Project Name: Kyden Truck Rental Office

# REVIEW COMMENTS

FILE #SPR-95-97

TITLE HEADING: Site Plan Review - Ryder Truck Rental Office

<b>RYDER TRUCK RENTAL SITE PLAN</b>			
GRAND JUNCTION, MESA COUNTY, COLORADO			
W.J. LEEZ AND ASSOCIATES ENGINEERING CONSULTING AND LAND SURVEYING 578 25 ROAD—UNIT B—PKA, 241-1129 GRAND JUNCTION, COLORADO 81505			
DATE	DRAWN	FIELD NO.	SCALE OR

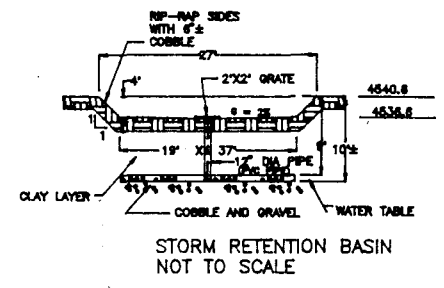
Drainage: I don't understand the concept of sizing a retention pond to contain all runoff and then attempting to discharge the water into the water table. I don't think this will work. Aside from questions about discharging directly into the water table, the pipe will fill in with sediment in a short time and will be non-functional.

SWMM Manual requirements need to be met as follows: Section VIII-13, Part E details the criteria for retention ponds, which includes a percolation test indicating the water can be dissipated within 48 hours. This needs to be submitted.

Grading for riprap slopes has a maximum side slope of 2:1 as per Table X-2.

The 0.5% grade shown for the drainage swale is too flat for dirt and will not reach the pond.

The volume appears to be correctly calculated, however, it is not clear from the drawing what the dimensions of the pond will be that correspond to the required dimension.

Site Plan: Section 5-1-4 of the Zoning and Development Code requires all required parking and vehicular traffic surface areas to be properly graded for drainage and surfaced with concrete or bituminous pavement. Gravel is allowed only for overflow parking or low-volume storage yards. The extent of the paved area is not clear on the drawing and does not appear to meet the criteria in the code.

Please indicate on the drawing if there is a culvert under the existing driveway, as well as type and size. Please show the radii for the driveway connection to F Road. 30' radii is probably appropriate.

Handicap parking spaces must be marked and signed as per the City Standard details. Please show the detail on the plans.

1. Increase the landscaping on the property to meet the required minimum of 75% of the required front yard setback (see 4-2-14-D of the Code). In this case, this requirement means 75% of the first 5' from the north property line. Code also requires that the right-of-way of be landscaped (see 5-4-15-G) and a street tree for every 40' of street frontage (see 5-4-15-H).

2. Indicate what will be the size of landscaping at the time of planting. The Code requires 1-1/2" caliper deciduous trees (measured one foot above ground level), six foot tall evergreen trees, and five gallon size shrubs (see 5-4-15-B).

3. Indicate on the plan that all landscaping will be irrigated by a pressurized, underground irrigation system, as the code requires (see 5-4-15-D).
4. Show the handicap symbol (painted on the asphalt) on the plan as required by Exhibit G of Standard Engineering Drawings.

5. Show on the plan a bicycle rack sufficient to hold three bicycles as required by Code (see 5-5-1-H-1). I have attached bike rack guide.
6. Indicate on the plan what areas will be paved and what will be gravel. Code requires that all vehicle travel areas be paved while storage areas can be graveled (see 5-4-1-A-1).

1. Show the handicap symbol (painted on the asphalt) on the plan as required by Exhibit G of Standard Engineering Drawings.
2. Show on the plan a bicycle rack sufficient to hold three bicycles as required by Code (see 5-5-1-H-1). I have attached bike rack guide.

3. Pave the area between edge of the pavement on the street to the parking lot in front of the building and to the beginning of the low-traffic storage yard (less than 30 ADT) per the Code (see 5-4-1-A-1).

5. The elevation certificate must be finalized before issuance of the Certificate of Occupancy.
6. Show on the plan what benchmark is being used for elevation.

8. Sewer service line must drain directly to 8" sewer in F Road, rather than to the existing 4" sewer service line, per the Code section 38-39.
9. Show on the site plan where the new 8" water line will be located, per Fire Department's requirement.

As shown on the attached Ryder Truck Rental Site Plan, the proposed Floor Elevation of the Rental Building is 4545.80, one foot above the Leach Creek 100 year Flood Elevation which is 4544.80 above mean sea level.

The Bench Mark, now shown on the revised plans referenced above, appears to be consistent with the Flood Insurance Rate Map (FIRM) which designates the area as A0, or having a flood depth of 1 to 3 feet.

The proposed site is within the flood fringe and not the flood way of Leach Creek and the impact of changing the Leach Creek watercourse is expected to be minimal to none.
